**WORKSESSION**

**Design Review Board Case EE/CDRB #2016-0002**

**2410 & 2460 Mill Road – Hoffman Town Center Blocks 4 & 5**

## **Design Principles for Hoffman Blocks 4 & 5**

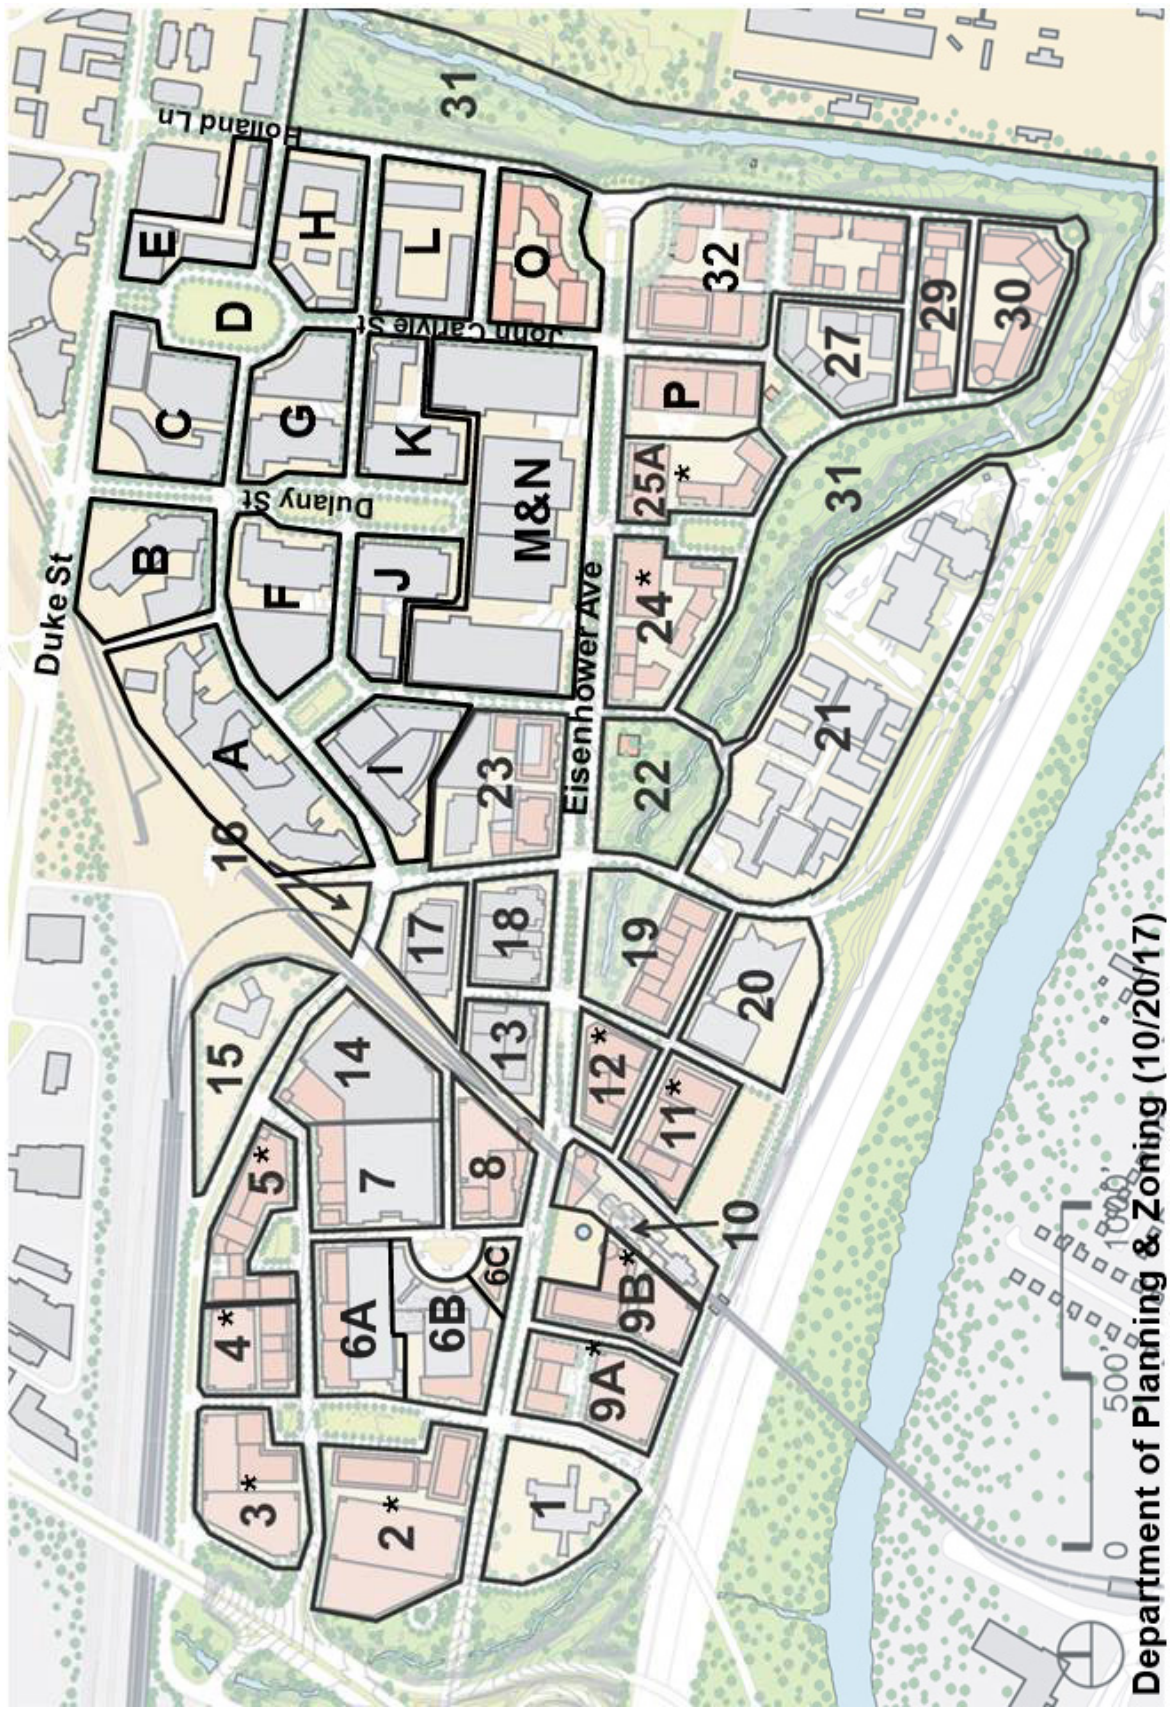
- a. Architectural quality and materials must comply with the Eisenhower East Design Guidelines for "A" Streets.
- b. Where tower architecture extends to grade, garage openings shall be fully glazed and consistent with the facade above. A diagram to achieve this was provided by staff (Page 7).
- c. Plan, section, and elevation details of the various systems proposed to achieve this screening need to be provided.
- d. Excessive use of corrugated and perforated screening materials to screen parking on Mandeville and Stovall is still a concern.

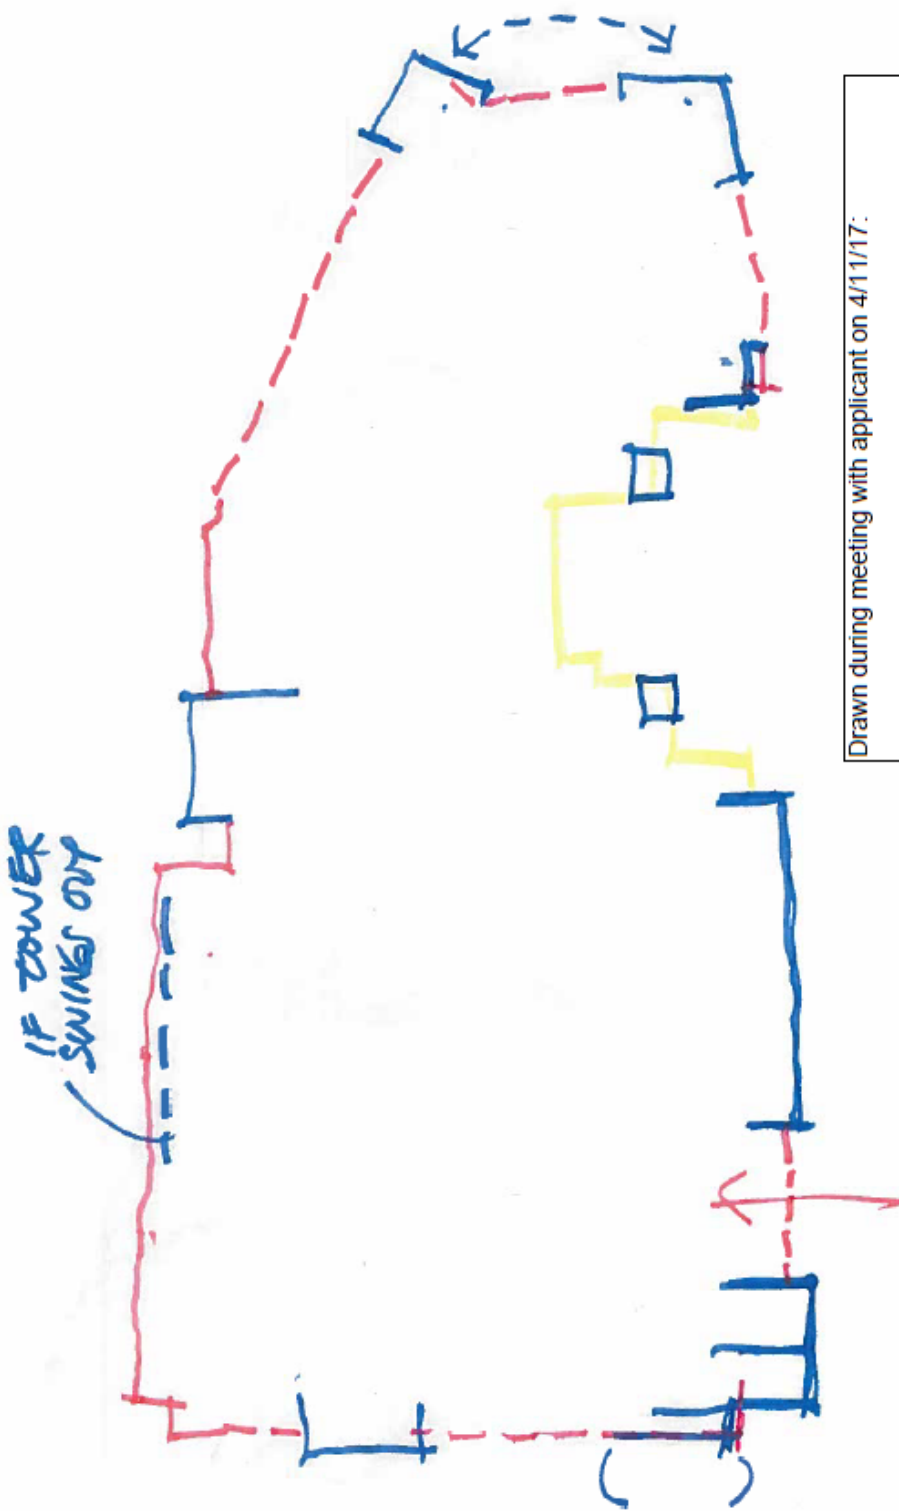
Guidelines call for the highest quality materials and details at pedestrian level. "A" street frontages have the most restrictive guidelines to ensure the highest quality character and appearance. The use of 8"x16" CMU on primary retail frontages on Stovall and Mandeville does not meet the letter or the spirit of the guidelines.

# Eisenhower East / Carlyle Blocks

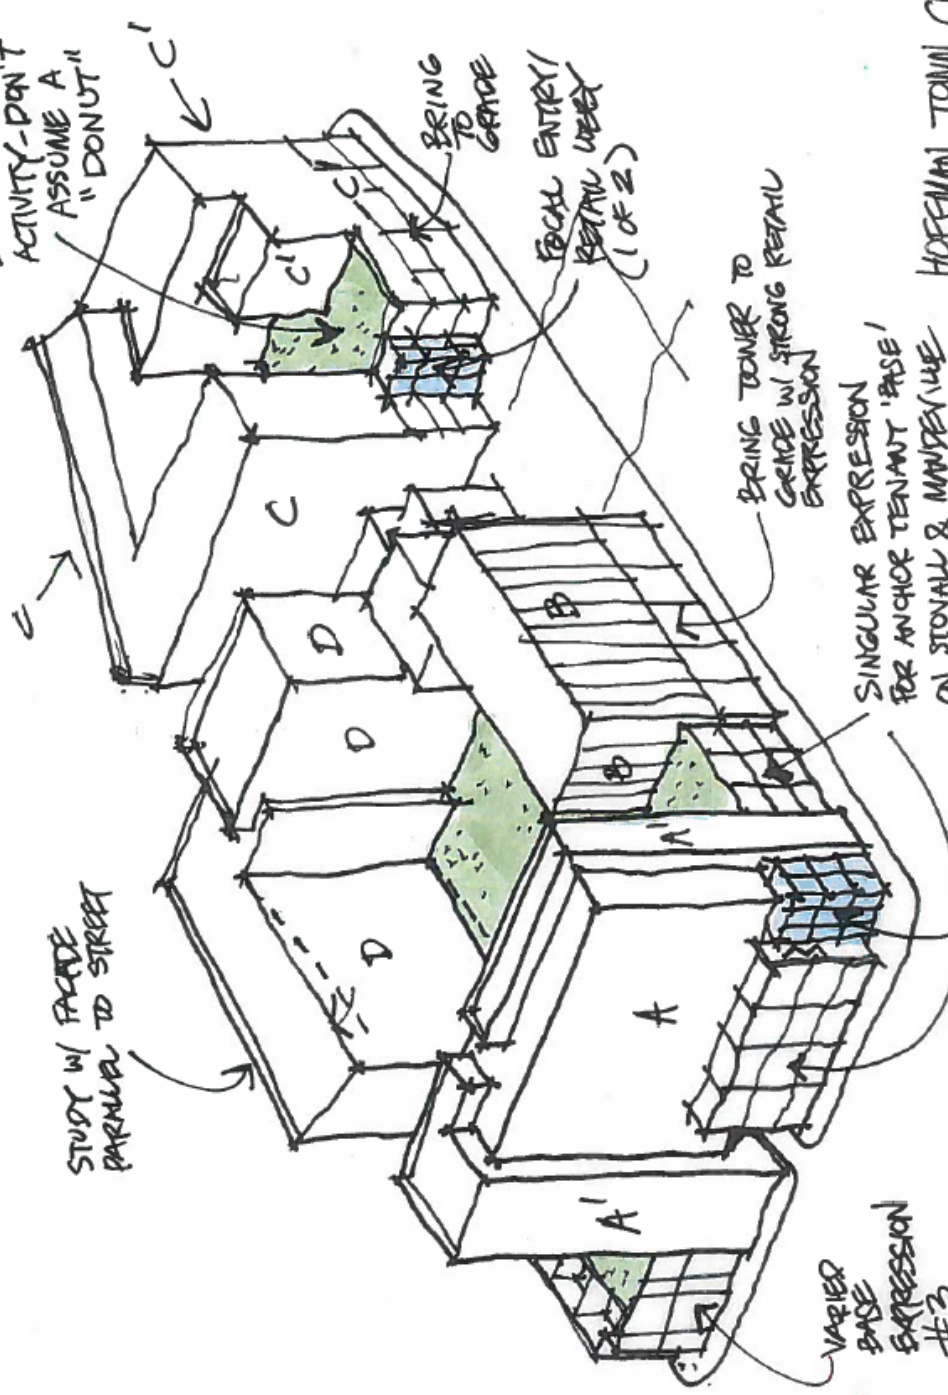
Drawn during meeting with applicant on 4/11/17:

**Blue** = glass must screen parking at podium levels  
**Red** = parking screening can be open or other materials  
**Yellow** = area of focus for architectural unity as recommended by DRB

HOFFMAN TOWN CENTER 4+5  
CONCEPTUAL MASSING/PARTI/EXPRESSION

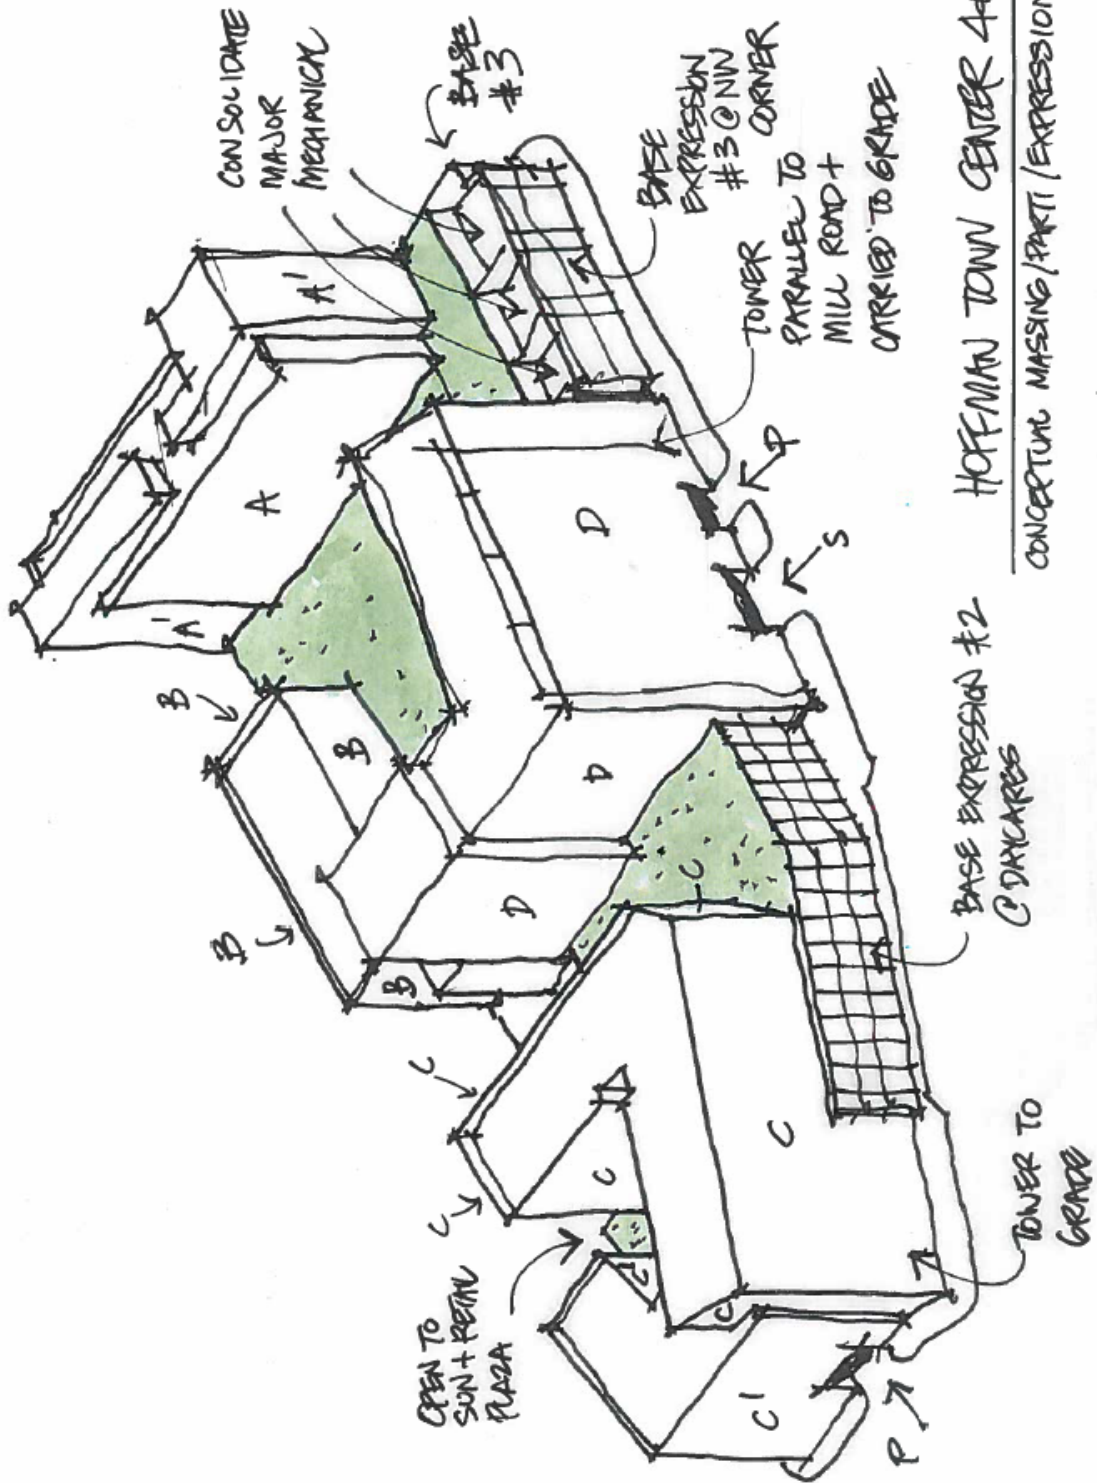
SHOW LIGHT COURT OPEN TO SUN + RETAIL ACTIVITY - DON'T ASSUME A "DONUT"
